ELLWOOD HOUSE

2262 BRAESIDE AVENUE TRANSPORTATION IMPACT ASSESSMENT FINAL REPORT

FEBRUARY 09, 2023

COMMENT AND RESPONSE LOG

Figure 2-2: Bicycle and Pedestrian Facilities

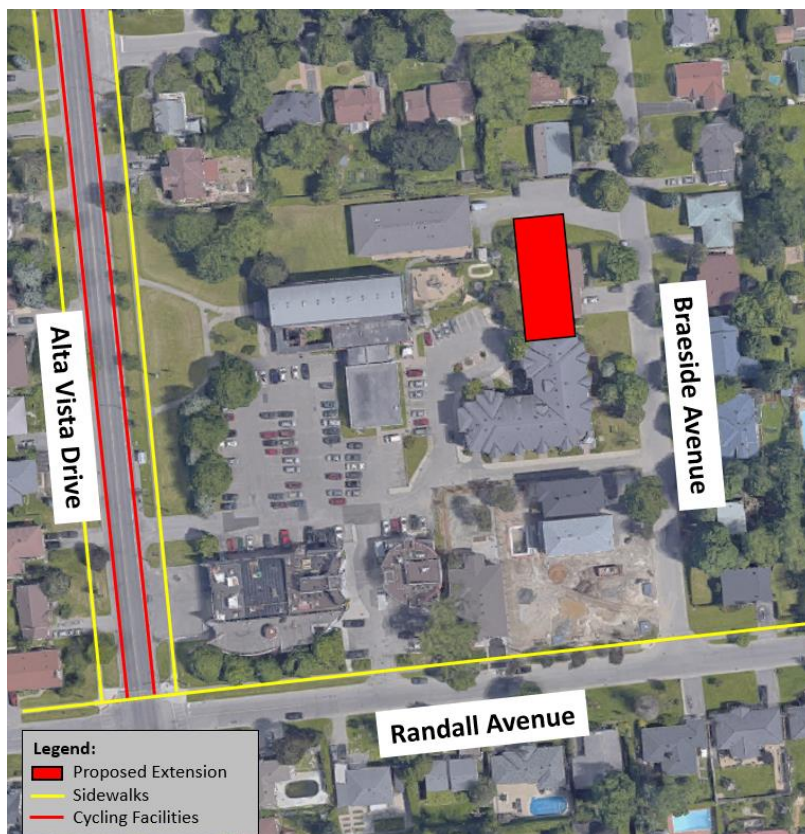
- 1 The legend of Figure 2-2 has an error: yellow lines are sidewalks, and red lines are cycling facilities
The figure has been updated in Section 2.3.1 of the TIA Final Report with the revised legend.

Figure 4-4. City of Ottawa, Standard Drawing SC 7.1 Curb Return Entrances, Private/Unsignalized (March 2017)

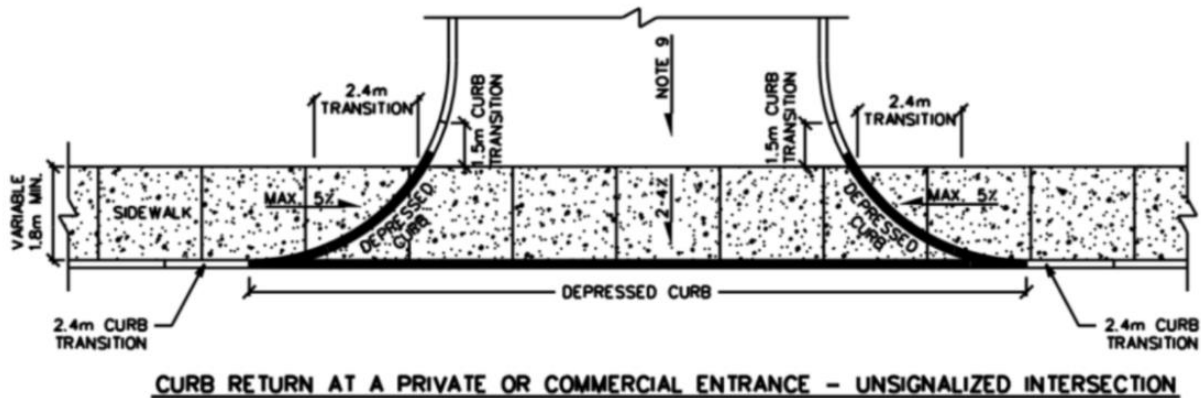
For the Alta Vista entrance, pedestrian accommodations at the accesses should follow the City of Ottawa’s Standard Drawing SC7.1 for Curb Return Entrances utilizing the Private / Unsignalized entrance option which includes a continuous depressed sidewalk across the access as shown below.
